TOWN OF OCEAN CITY

ADDENDUM # 1: Ocean Bowl Admin Building

Date of Addendum: 6/10/24

OCEAN BOWL ADMIN BUILDING
3RD STREET/ ST. LOUIS AVENUE
OCEAN CITY, MARYLAND

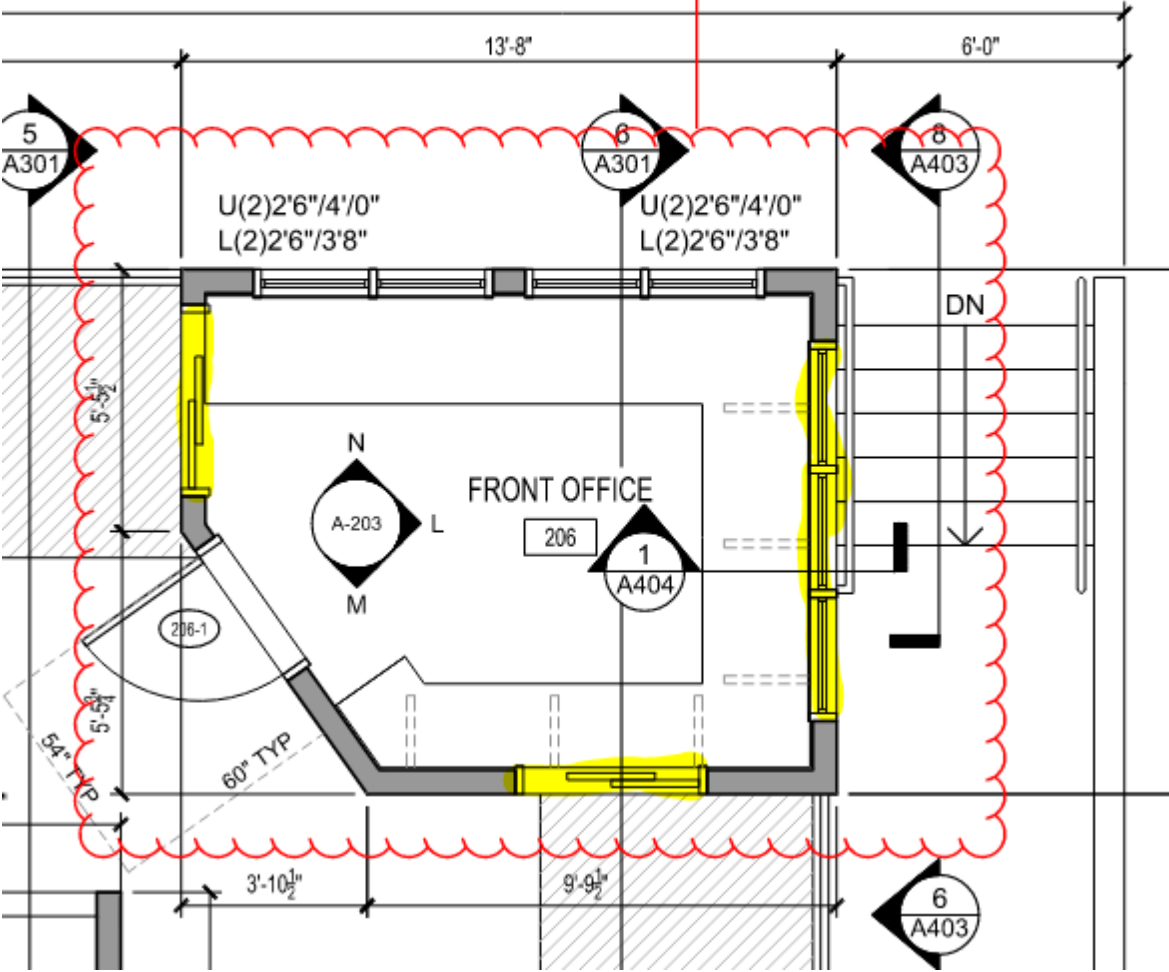
2.0 Please see image below and provide opening sizes. East Side Lower (3)2'6"x3'8"Upper (3)2'6"x2'4" Height of upper window is a starting point, follow slope of roof. Refer to Basis of Design Product Specs on A-102 for (2) Transaction Sliders. Note on Elev M/A-203 refers to the Transaction Sliders as Self Closing Slider Service Window.

Please give sizes for highlighted openings.

Dwg No.: **A-101**

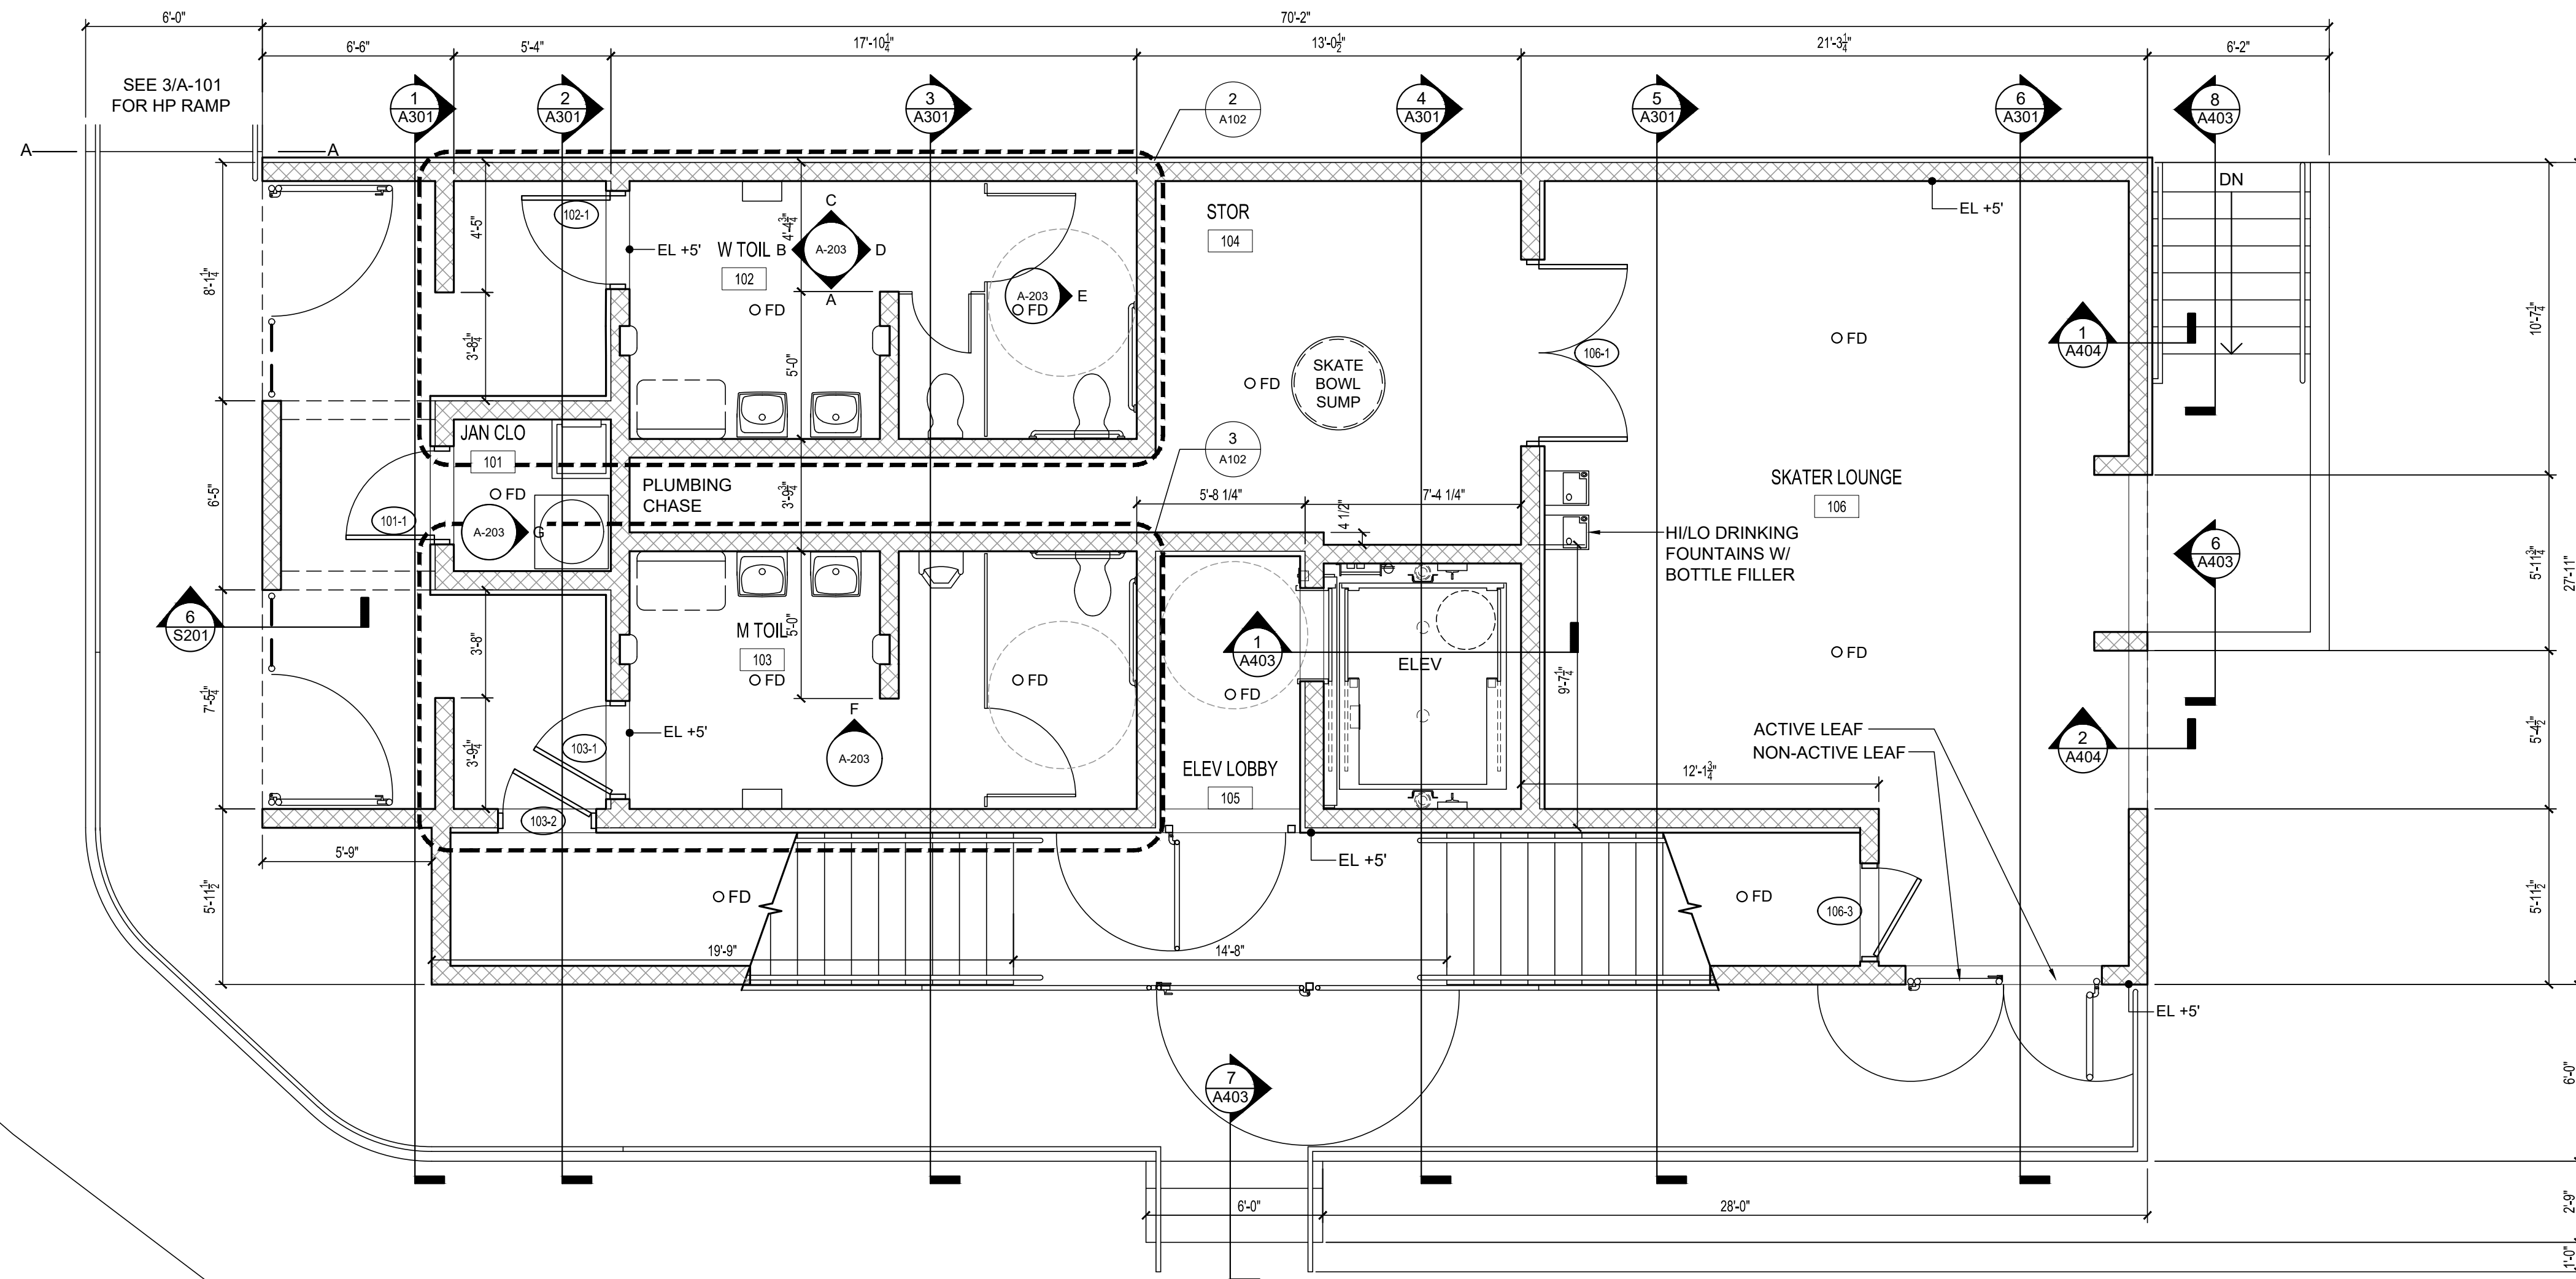
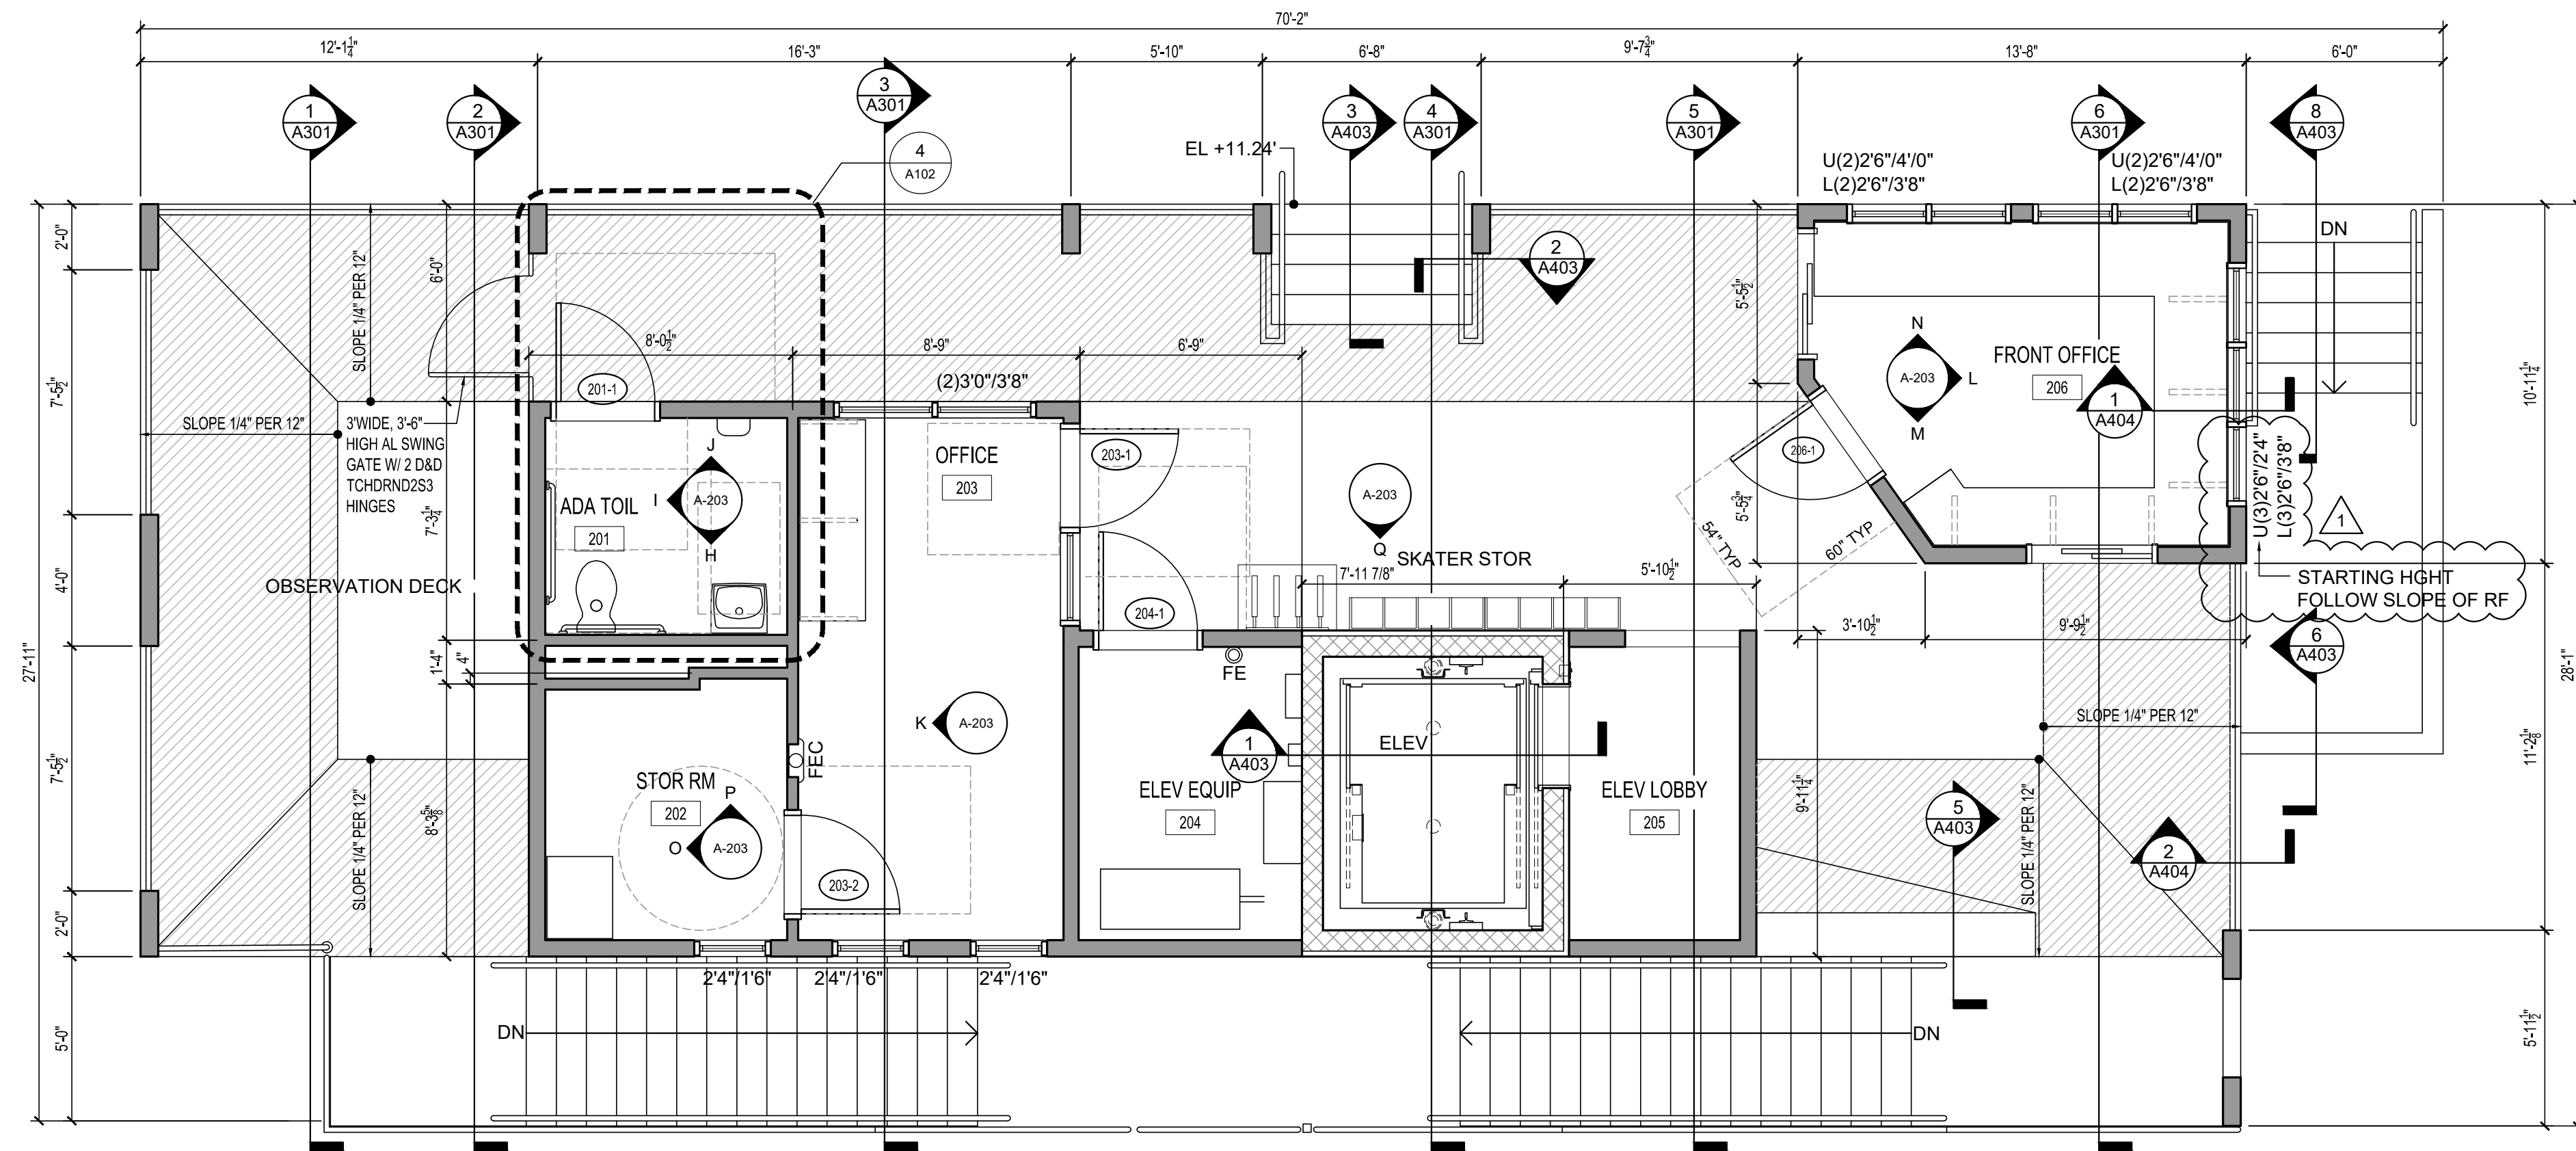
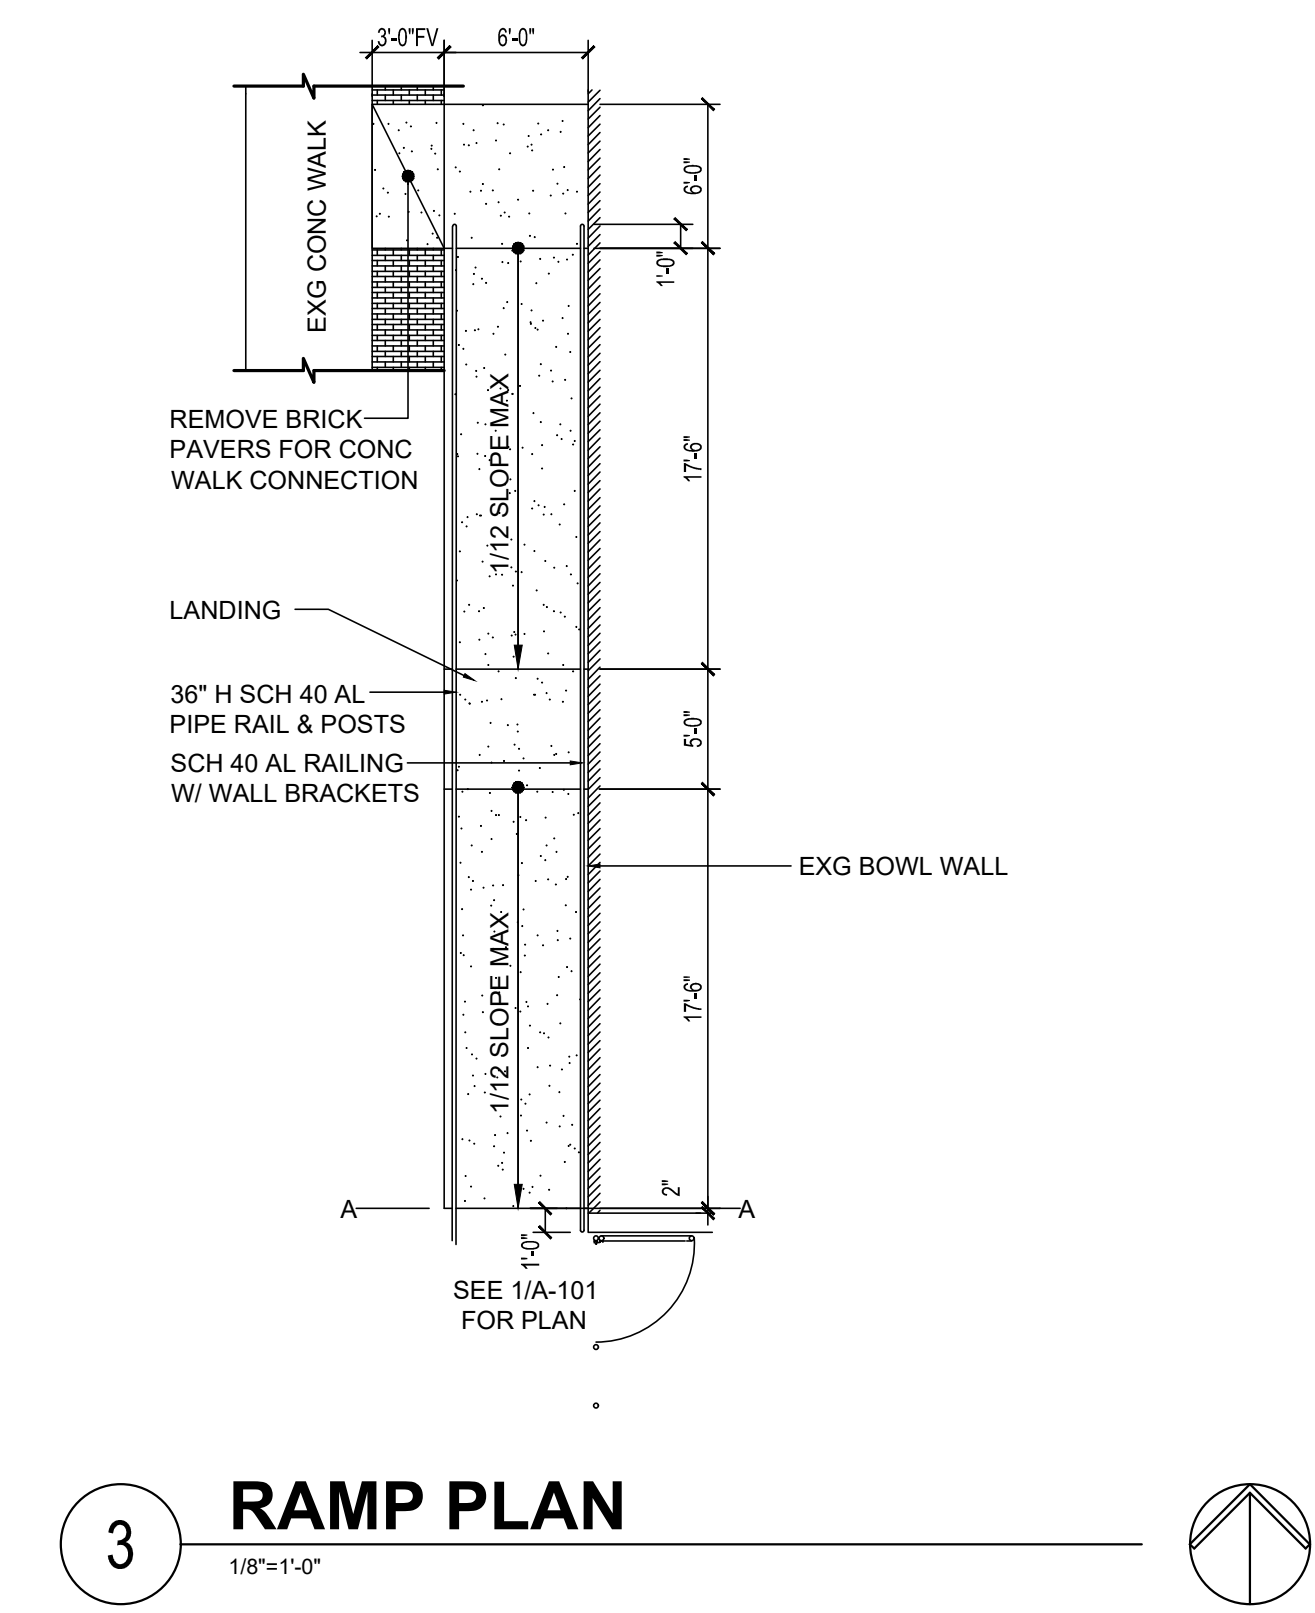
Item	Questions and Answers
1.1	The Town has decided to extend the Last Day for Questions until Friday, June 28, 2024 at 3pm.
1.2	Referencing sheet A-101 and the paver removal. Do you have a better cut that illustrates the amount of pavers that have to be removed? The pavers will be removed and replaced by TOC DPW.

16/6/2024 WINDOW SIZE
Date: 04/17/2024
Scale: NOTED
Dwn By: CULLEN
Proj No.: 2145A005.B01
